PCN# 20240613003.1A

**Qualification of RFAB using qualified Process Technology, Die Revision, and additional Assembly Site (JCETCZ) & BOM options for select devices
Change Notification / Sample Request**

Date: August 28, 2024

Sample product shipping label (not actual product label):

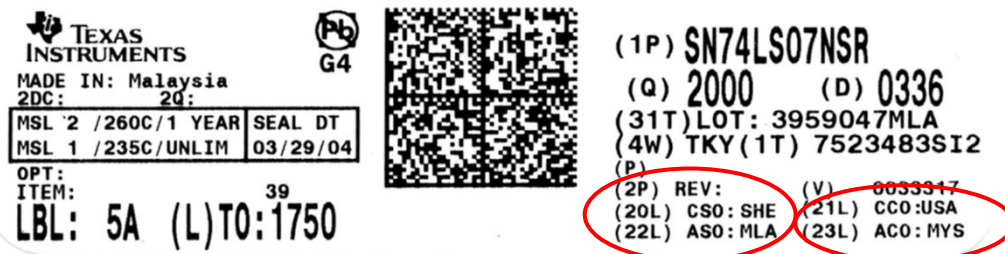
Changes to product identification resulting from this PCN:**Fab Site****Information:**
